SERVICE BULLETIN

APPLICABILITY: 2000MY and Later Legacy/Outback
 2.5L SOHC Vehicles
 1999MY and Later Impreza and
 Forester 2.5L SOHC Vehicles

NUMBER: 07-60-07R
DATE: 04/25/07

SUBJECT: Ignition Coil and High Tension Cables

FIGURE 1

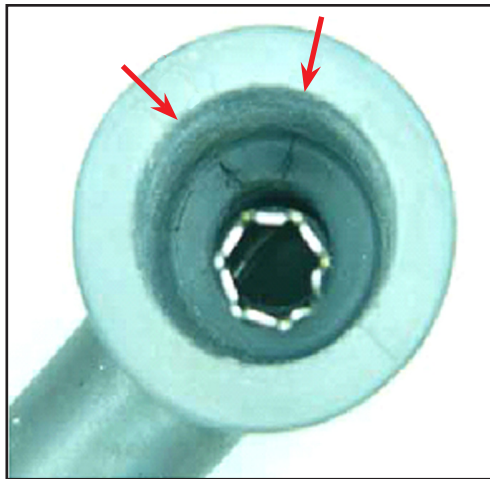
Check the tower portion of the ignition coil for carbon tracks (leakage). If leakage is more than 5mm long, the ignition coil and high tension cables should be replaced (see Figure 1).

Example of leakage on ignition coil tower.
